HISTORIC AND DESIGN REVIEW COMMISSION

HDRC CASE NO: 2022-555
ADDRESS: 400 CLUB DR
LEGAL DESCRIPTION: NCB 7013 BLK LOT 9
ZONING: RM-4, H
CITY COUNCIL DIST.: 7
DISTRICT: Monticello Park Historic District
APPLICANT: Adrik Garcia Linares/IDEA INTERNATIONAL LLC
OWNER: Adrik Garcia Linares/IDEA INTERNATIONAL LLC
TYPE OF WORK: Window modifications, roof repair and modifications
APPLICATION RECEIVED: November 09, 2022
60-DAY REVIEW: Not Applicable due to City Council Emergency Orders
CASE MANAGER: Jessica Anderson

REQUEST:

3. New Windows on the addition: request to be Steel, similar to main house

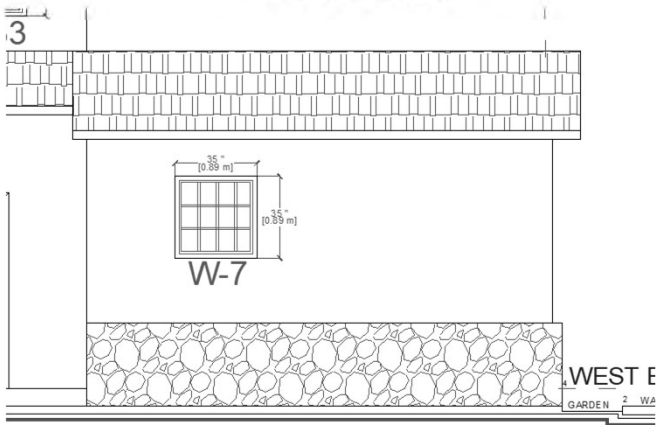
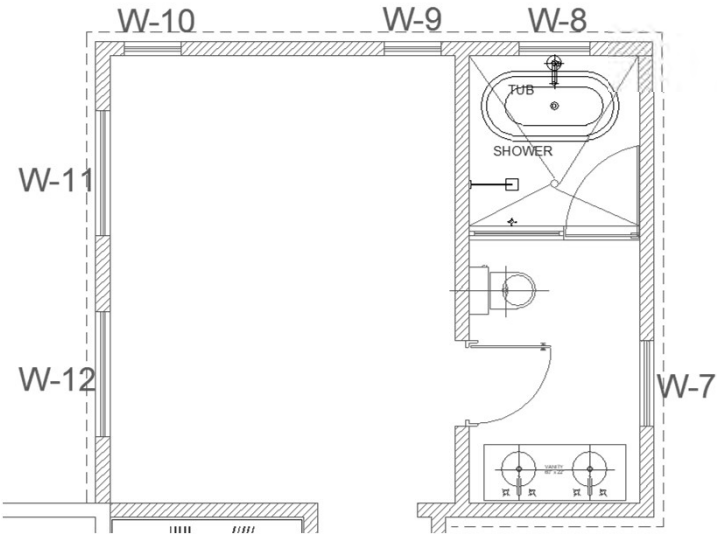
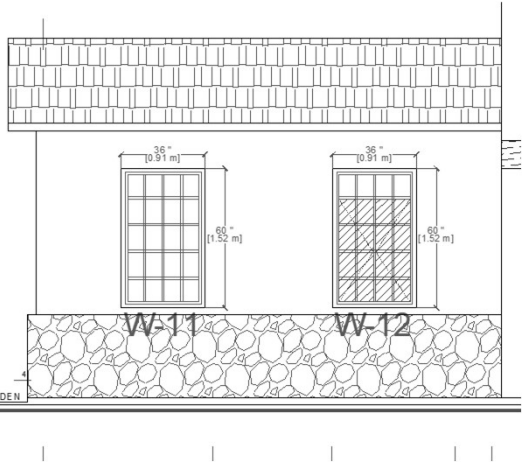
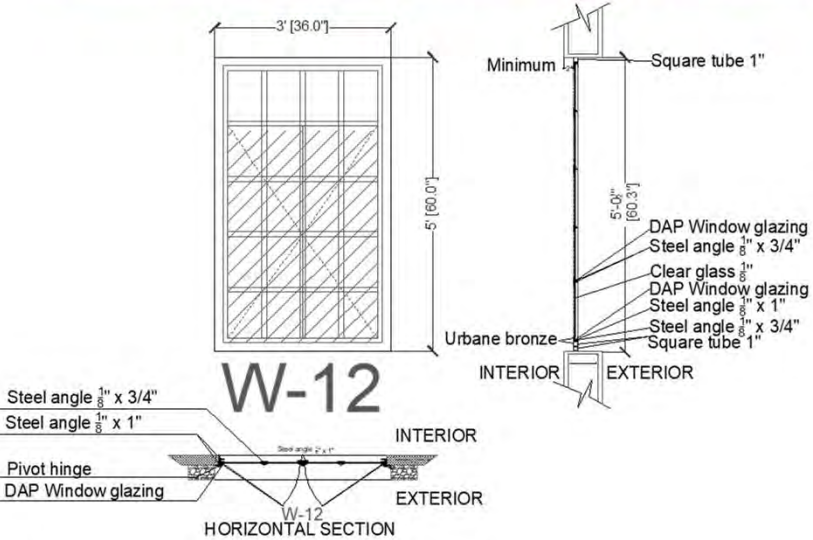
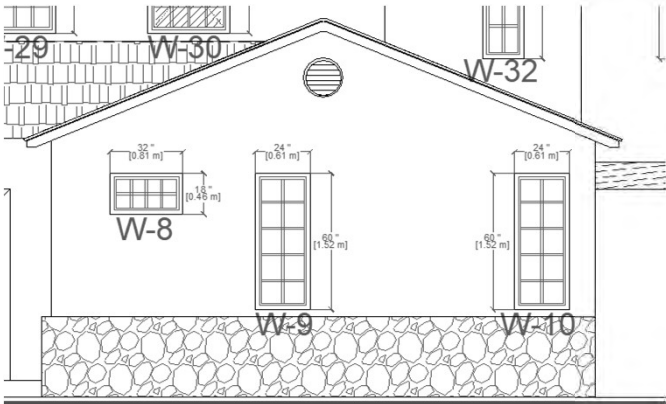
- d. ADDITION (WINDOWS): The applicant proposes to install two 20-lite casement windows to the west side of the addition, two 10-lite casement windows and one eight-lite casement window to the south side of the addition, and one 12-lite casement window to the east side of the addition. Historic Design Guidelines for Additions 4.A.i states that additions should be designed to reflect their time while respecting the historic context, and that character-defining features and details of the original structure such as shapes of window and door openings should be considered in the design of additions. Staff finds the use of casement windows on the addition conforms to guidelines.

WINDOWS
Steel Casement Windows
Colonial Grid
Clear Glass

Staff recommends approval of item 1, modification of proposed windows on a previously-approved addition, based on finding d.

4. Roof

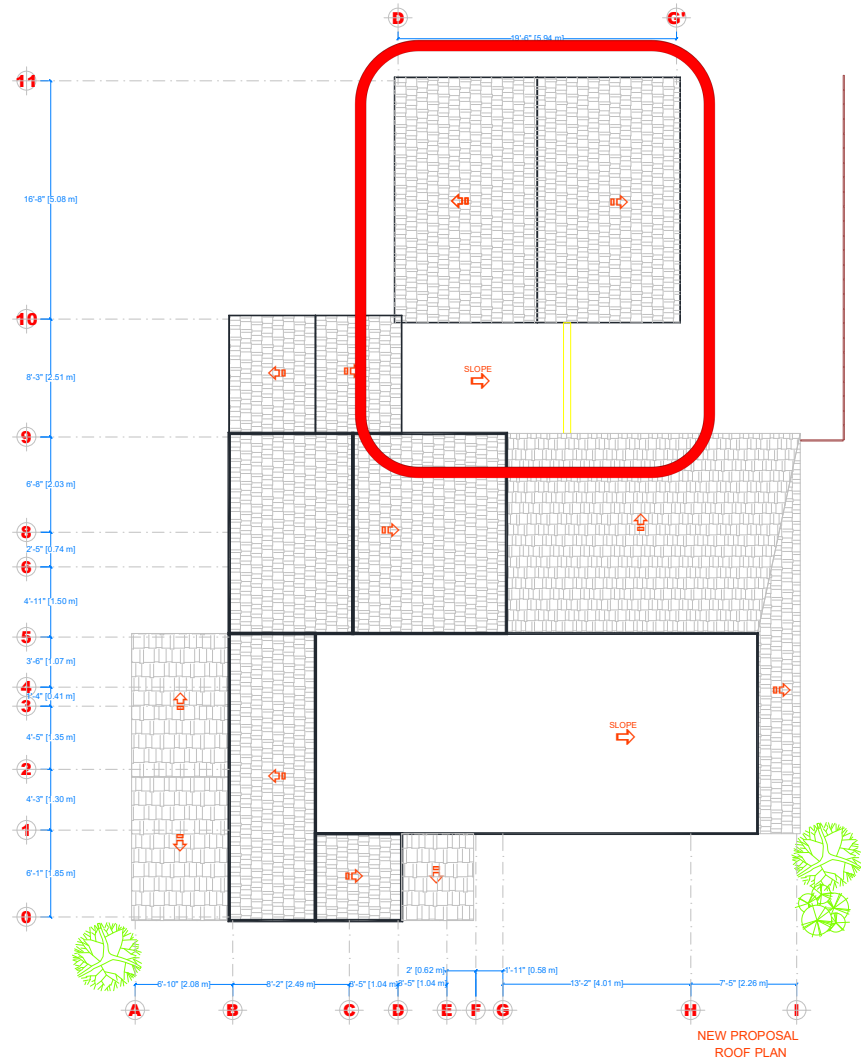
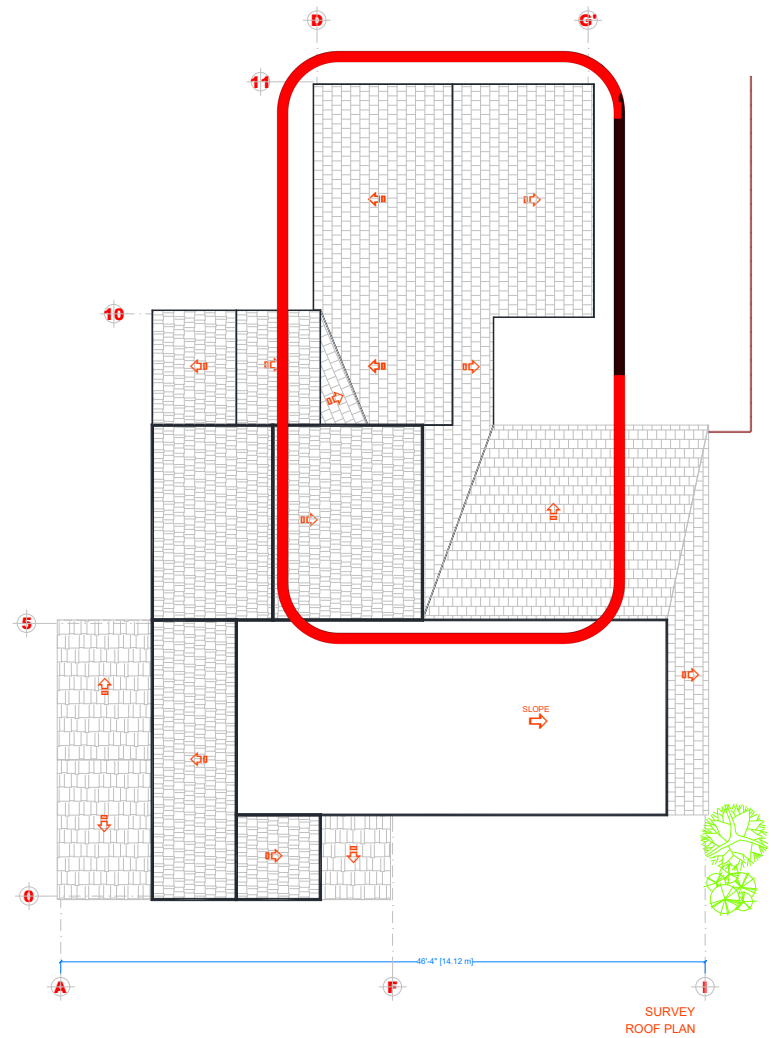
- e. ADDITION (ROOF FORM): The applicant proposes a roof form that connects the one-story addition to the rest of the house. As proposed, the new roof form intersects with the existing roof form in a non-traditional manner. Staff finds the proposed roof form generally appropriate. Given multiple roof additions over the years, there are several instances of non-historic roofs tying into one another. Based on photos submitted, there is concern for adequate drainage to support the longevity of the historic home. It would be more appropriate to consolidate and simplify the overall roof forms at the rear to ensure adequate water shed from the historic structure.

- Roof project adjustment to connect old house and addition

Staff recommends approval of item 2, modification of the roof form, based on finding e, with the following stipulation:

- i. That the applicant proposes a roof form that is as simplified as possible and allows for drainage away from the house.

5. Roof

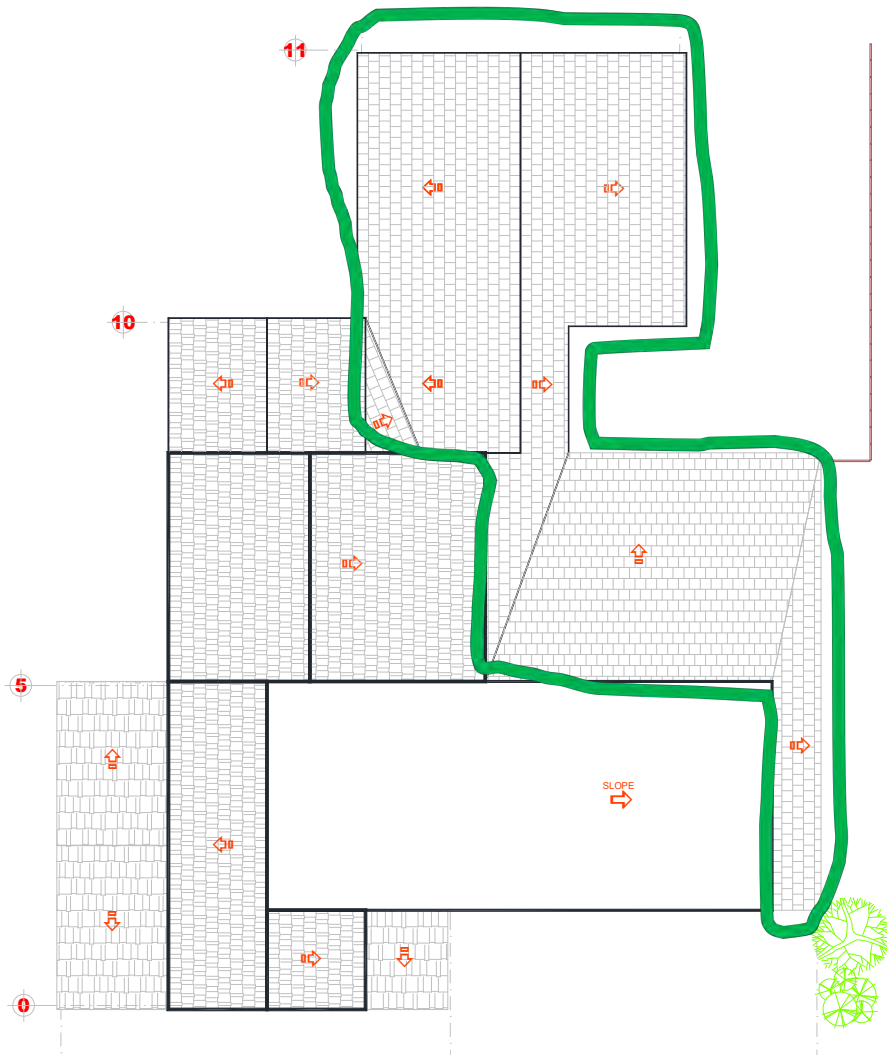
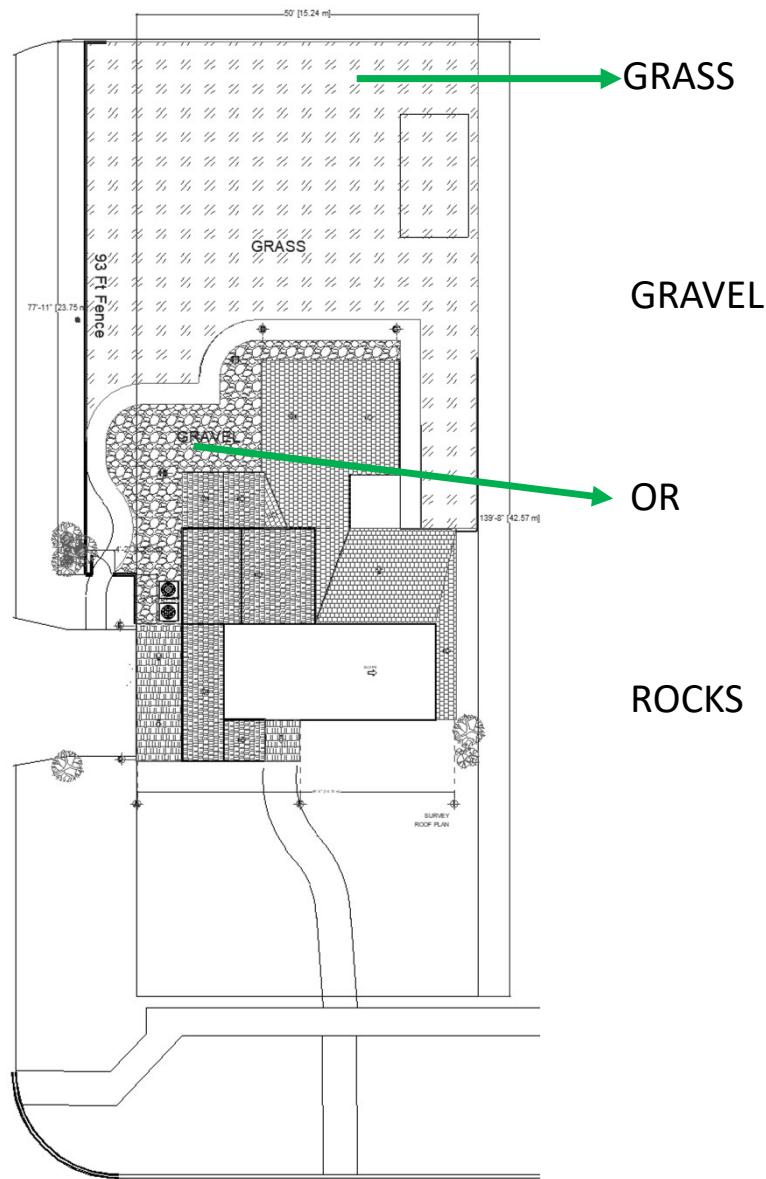
- f. ADDITION (ROOF MATERIAL): The applicant proposes installing a barrel-tile roof on the addition and the connection between the addition and the rest of the house. The previously-approved design for the addition included a largely composition shingle roof with a band of barrel tile at the edges to mimic the addition that was removed. Sloped roof forms on the house feature barrel tile. Historic Design Guidelines for Additions 3.A.i states that new materials introduced to the site as a result of an addition must be compatible with the architectural style and materials of the original structure, Staff finds the proposed barrel tile roof conforms to guidelines.

- Request to use new roof tiles for the roof addition and the old house

Staff recommends approval of item 3, installation of a barrel tile roof to the addition and proposed roof connection, based on finding f.
